# MANUAL CHANGES

Model Number: 8690B  
 Date Printed: May 1972  
 Part Number: 08690-90018

9 DECEMBER 1975

Page 7-3, Figure 7-2:

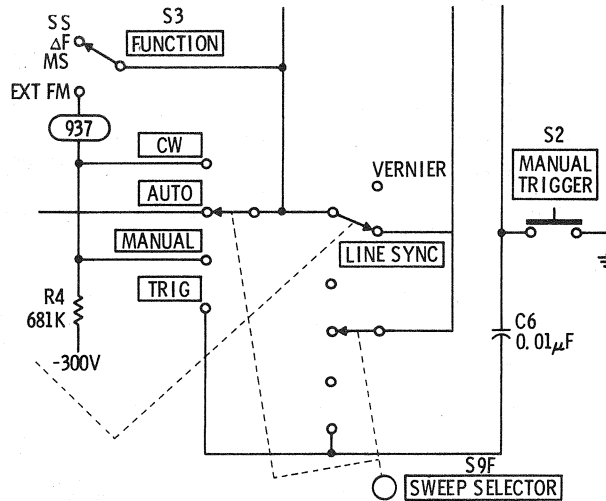
Change switch labeling as shown below:

P/O Figure 7-3. Frequency Control Section Reciprocal Amplifier

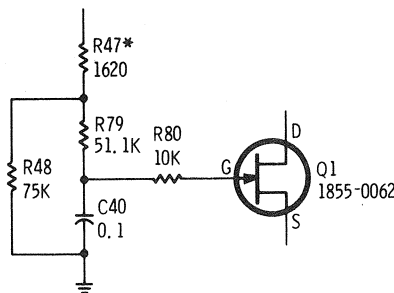
Change the circuitry of A3Q1 as shown in the attached drawing:

Component Identification, Assembly A9

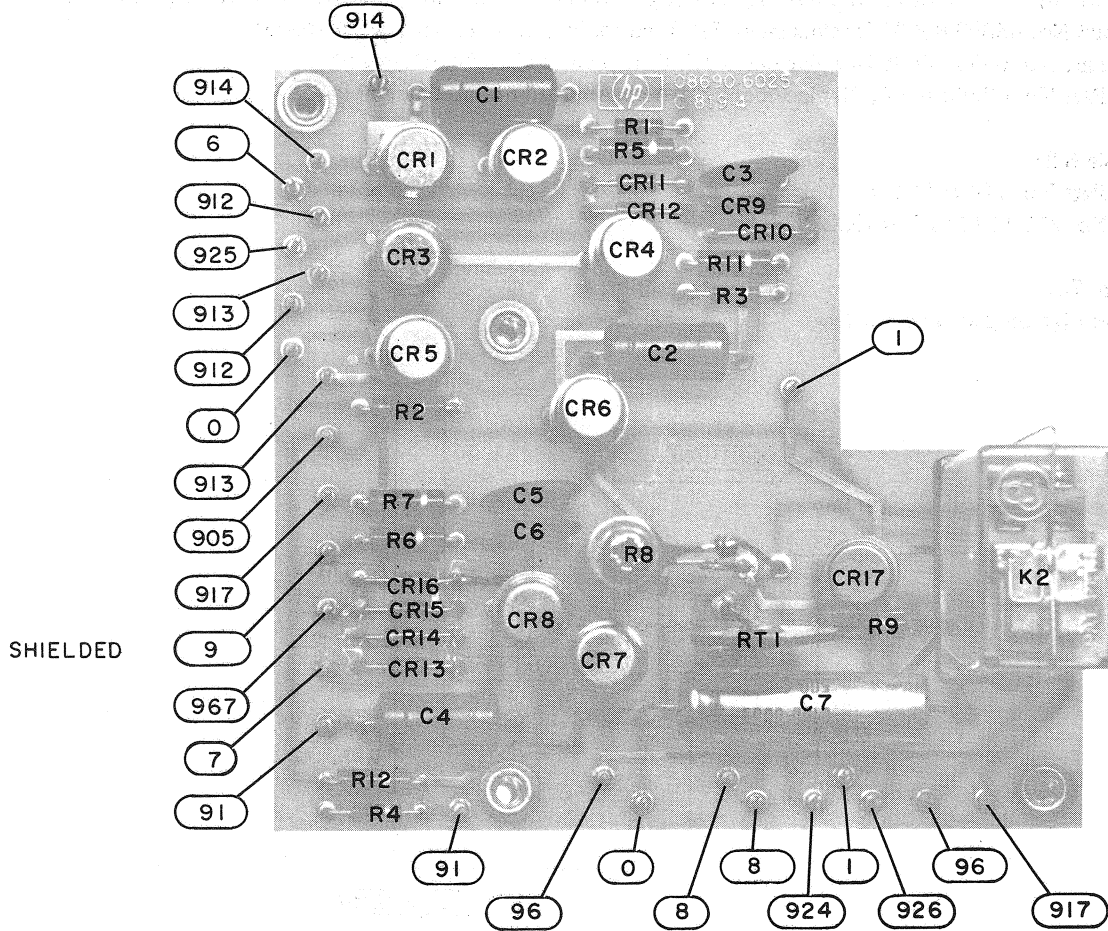
Substitute the attached A9 Component Identification board for that shown in the 8690B Manual.

Figure 1. Component Identification, Assembly A8 (Part of Change 1)

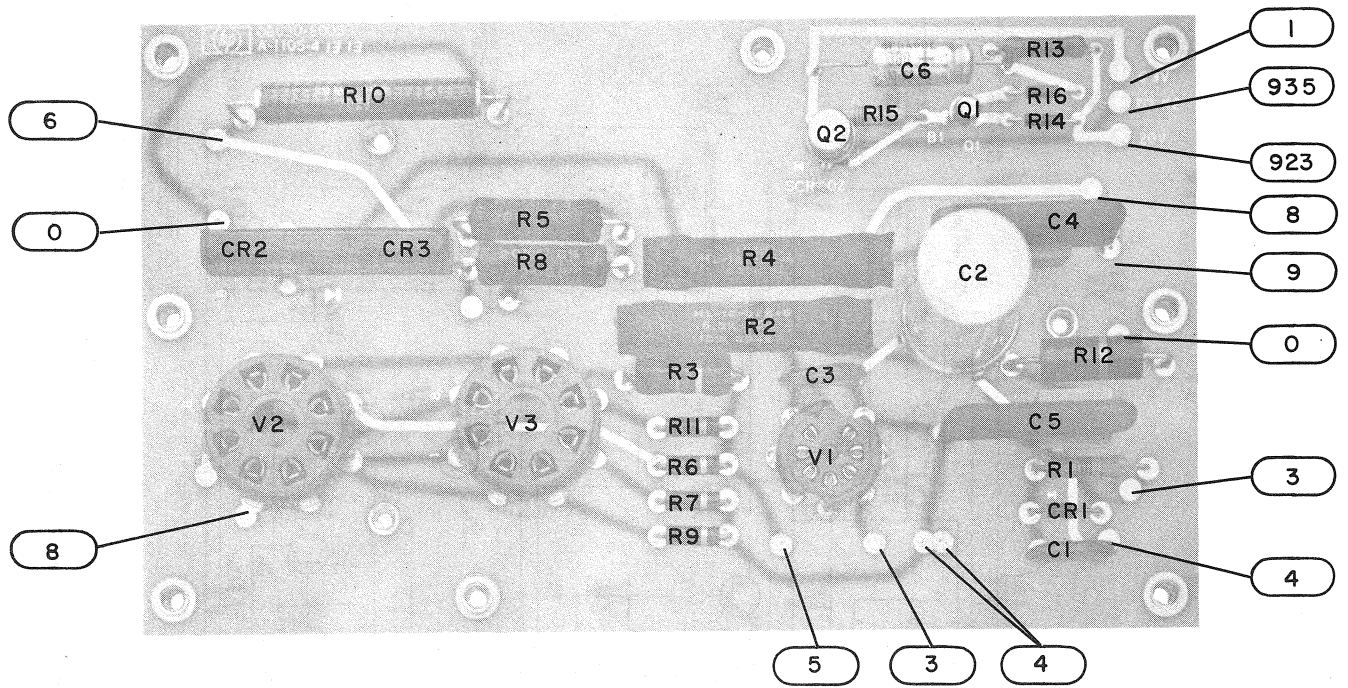
Substitute the attached A8 Assy, Component Identification board photo (Figure 1) for the photo shown in the 8690B Manual.

Figure 2. Component Identification, Assembly A14 (Part of Change 2)

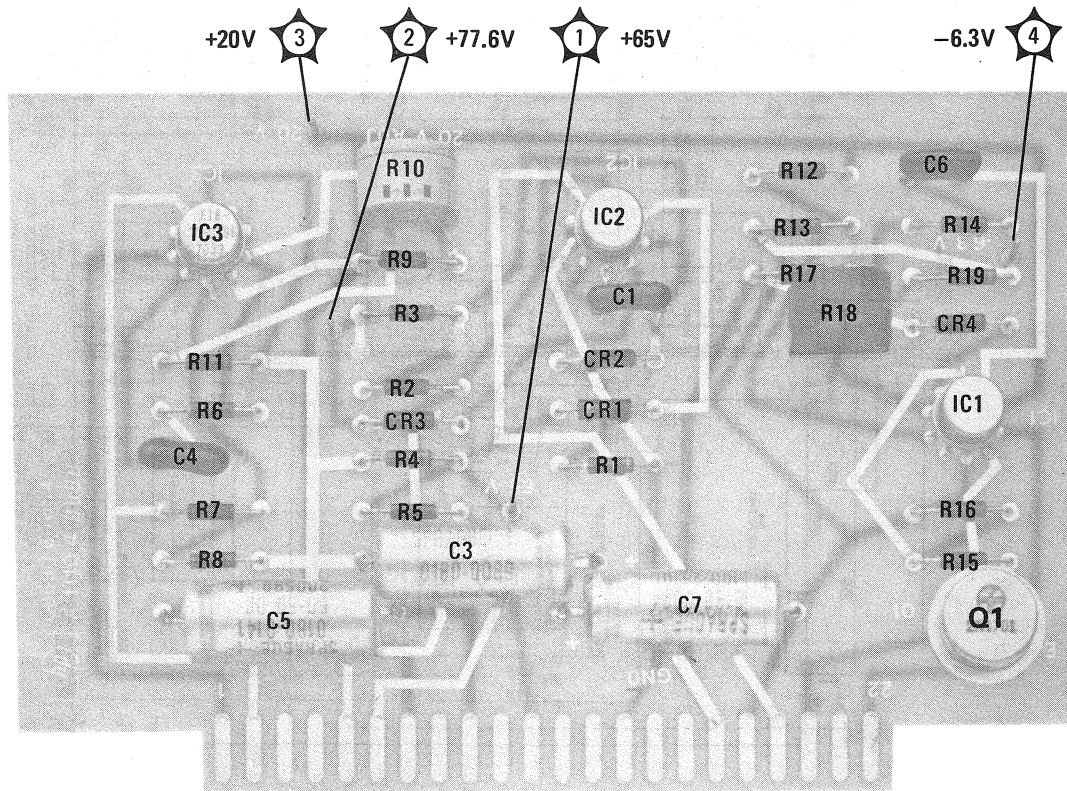
Substitute the attached A14 Assy board photo and schematic (Figures 2 and 3) for those shown in the 8690B Manual.

Figure 4. Component Identification, Assembly A4 (Part of Change 5)

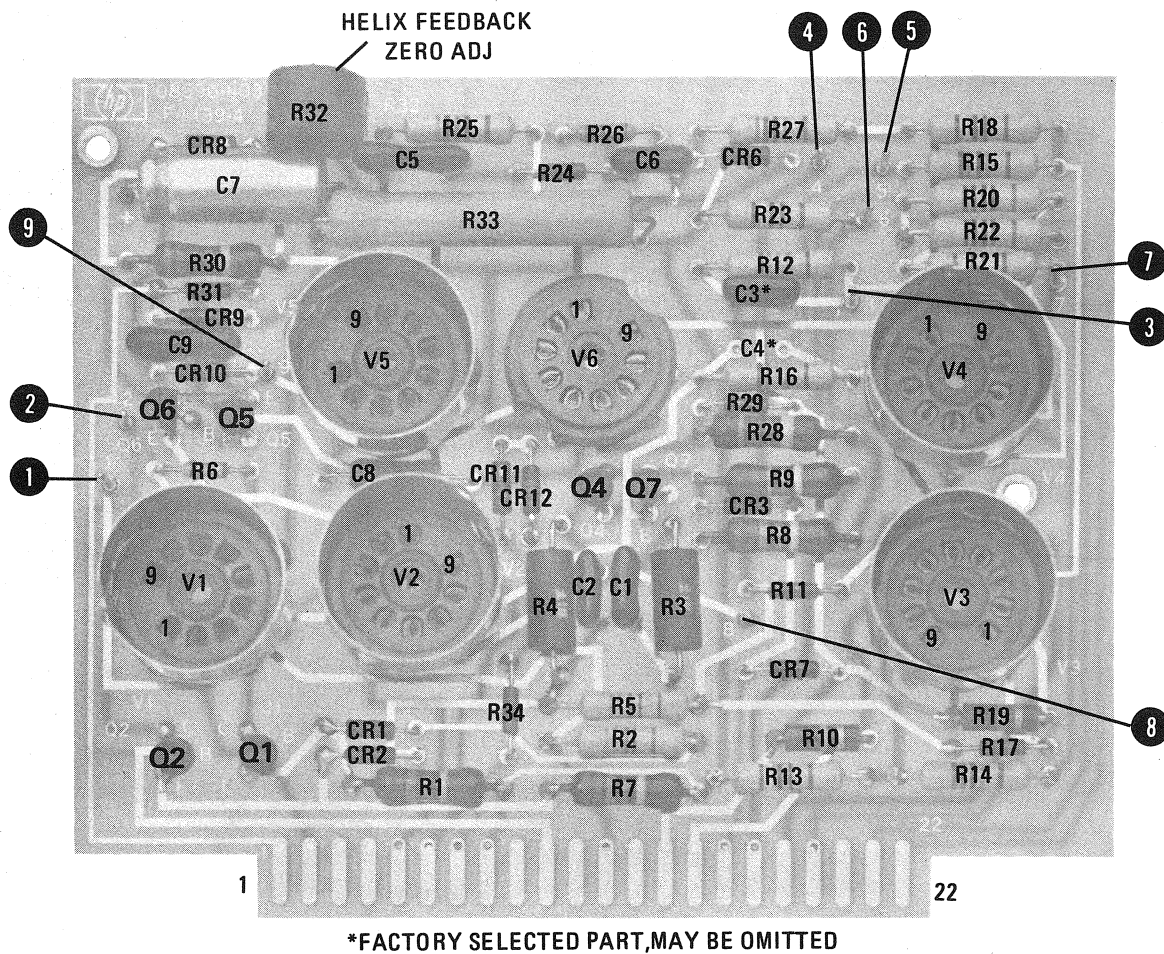
Add diode A4CR12 in series with zener diode A4CR11. Connect cathode of A4CR12 to ground, and anode to A4CR11.

Figure 5. Component Identification, Assembly A3 (Part of Change 1)

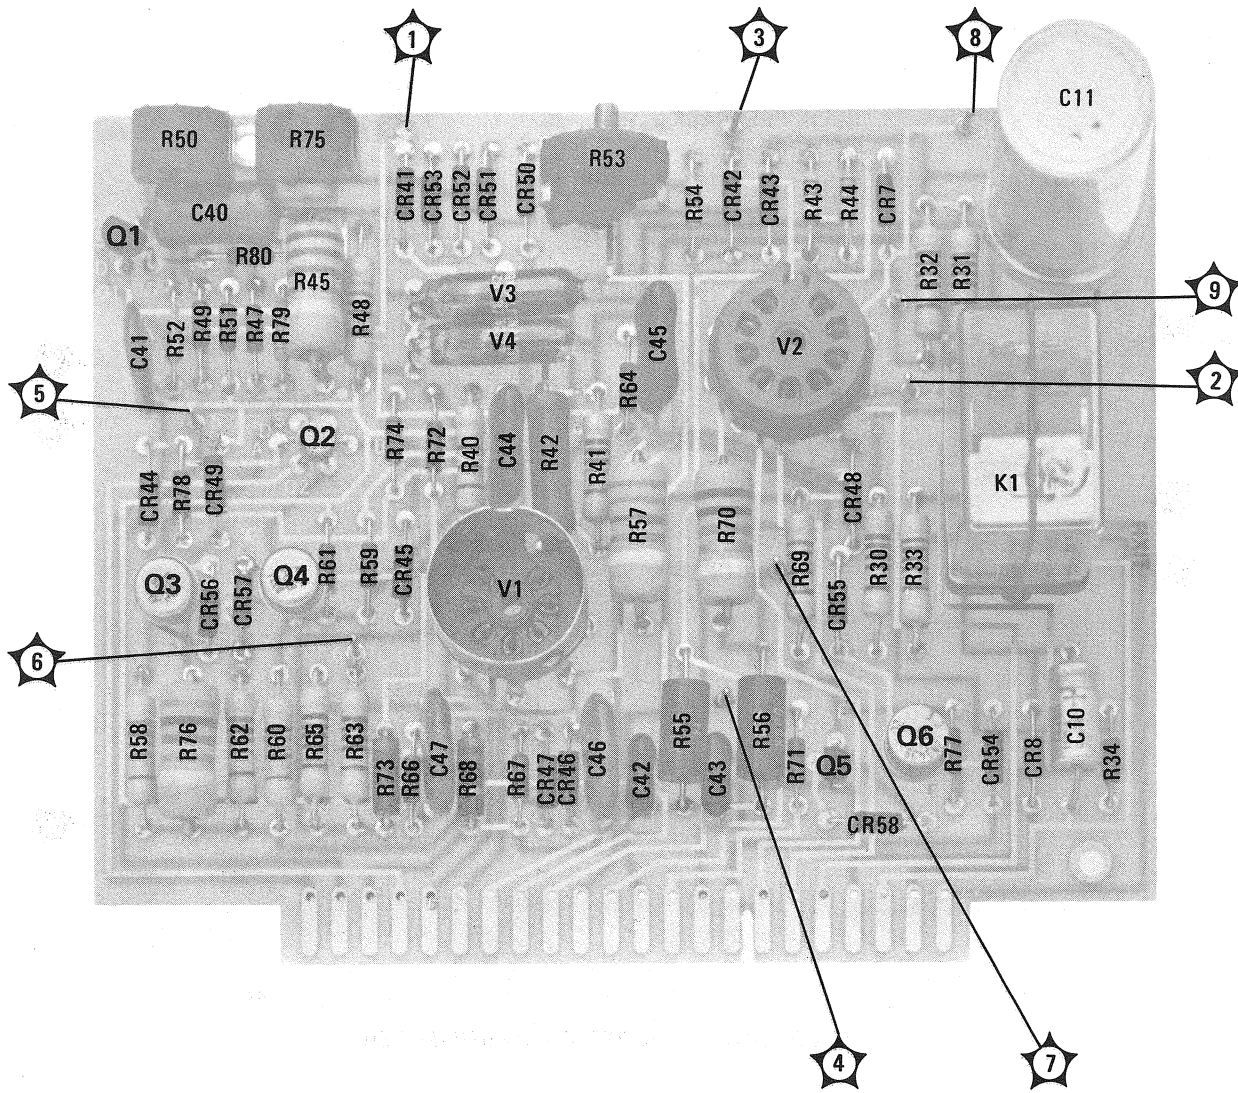
Add diode A3CR56. (Connect anode to source of A3Q2A and cathode to emitter of A3Q3.)

Add diode A3CR57. (Connect anode to source of A3Q2B and cathode to emitter of A3Q4.)

Add diode A3CR58. (Connect anode to base of A3Q5 and cathode to emitter of A3Q5.)

Substitute the attached Component Identification Assembly A3 board photo (Figure 5) for the photo shown in the manual.

Figure 6. Partial Schematic Diagram of the Power Supply Section Showing Thermal Switch S15  
(Part of Change 11)

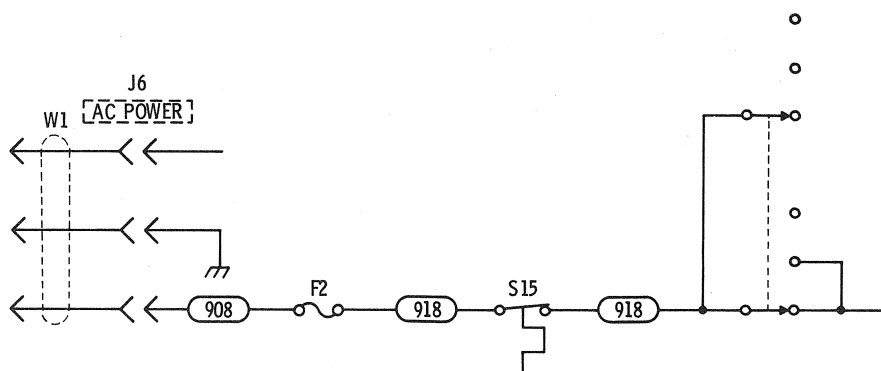
Add thermal switch S15 to schematic diagram of Power Supply Section as shown in Figure 6.
